Report to Planning and Environment Committee

Subject: 135 Villagewalk Boulevard
2560334 Ontario Limited c/o York Developments
Public Participation Meeting

Date: May 31, 2021

RE: Site Plan Consultation: 135 Villagewalk Boulevard

Site Plan

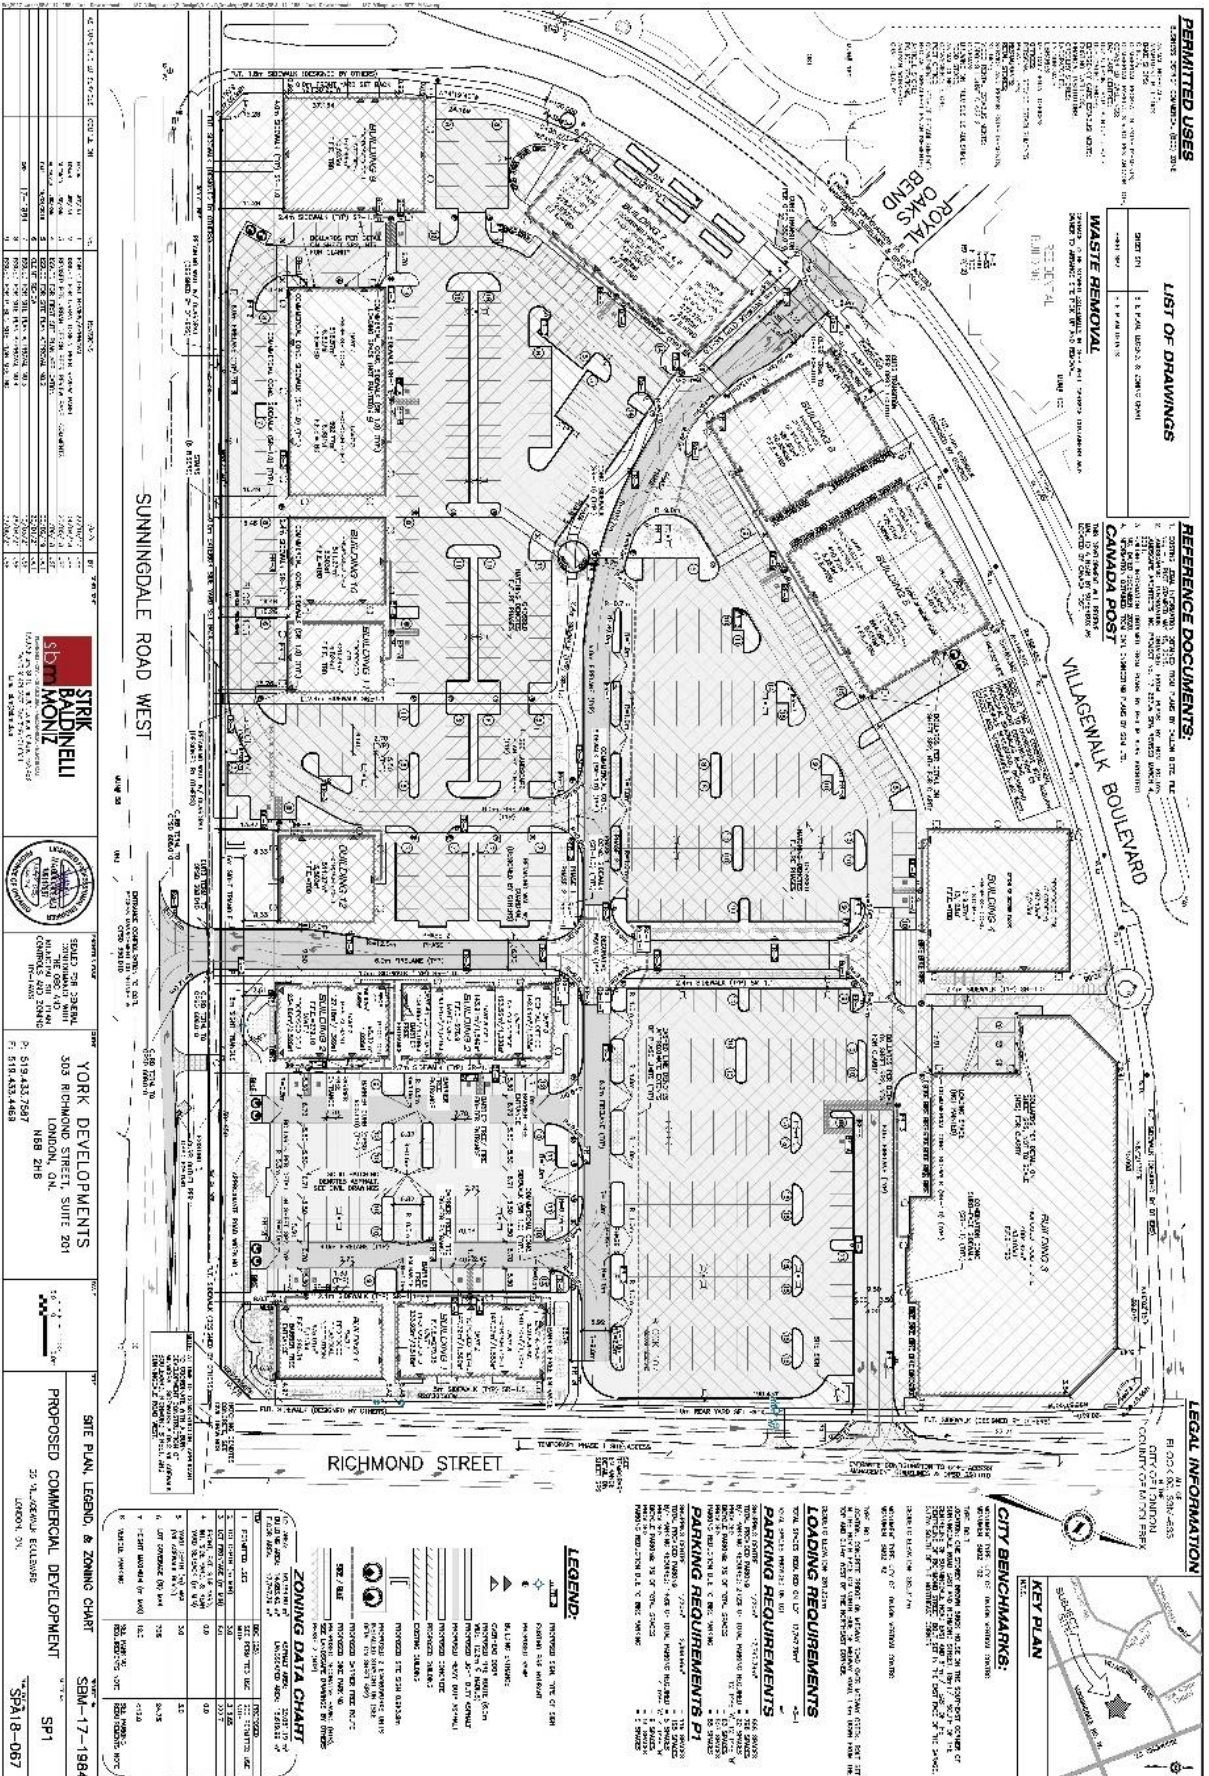
- *Buildings should have active frontage along Sunningdale Road and Richmond Street. Parking should not be located between the building and street. Where parking is not screened by buildings, substantial landscaping should be incorporated.*

- *Greater massing should be placed at the corner of Richmond Street and Sunningdale Road to address this major intersection.*
- Architecturally, the project would benefit from being considered as a campus that includes design elements that relate among all buildings. The design as presented appears disparate among buildings/building types.

- *The north/south pedestrian connection should be redesigned to consider the pedestrian experience. It should not lead pedestrians between the major loading areas on site. The terminus views should also be considered in the layout.*

- Consideration should be given to the design of loading to potentially consolidate between street-facing buildings and internal buildings.
- *Encourage only providing minimum parking to allow more flexibility on site to redesign and support pedestrians and active transportation.*

Not incorporated. Current Imperial Oil easement is a major constraint for site development. Landscaping requirements are being met with the current design and it is not feasible to replace parking stalls with landscaping. This would render the development unfeasible.

Nevertheless, the applicant has implemented the following strategies to allow for an enhanced street front configuration:

- Patios are incorporated facing Sunningdale Road West at Buildings 11, 12 and 14.
- Low landscape walls are shown at the edge of the property to buffer parking areas.
- Stone piers have been incorporated to mark all pedestrian connections.
- Enhanced landscaping has been provided.

Not incorporated. Site plan design provides adequate massing at intersection and incorporates landscaping enhancements to accentuate the corner element.

Refer to revised design. Landscape design has been revised to minimize the impact of loading areas (if any).

The applicant believes that the design of the proposed development supports pedestrian circulation throughout the site. Terminus points as well as destination points have been created throughout the site.
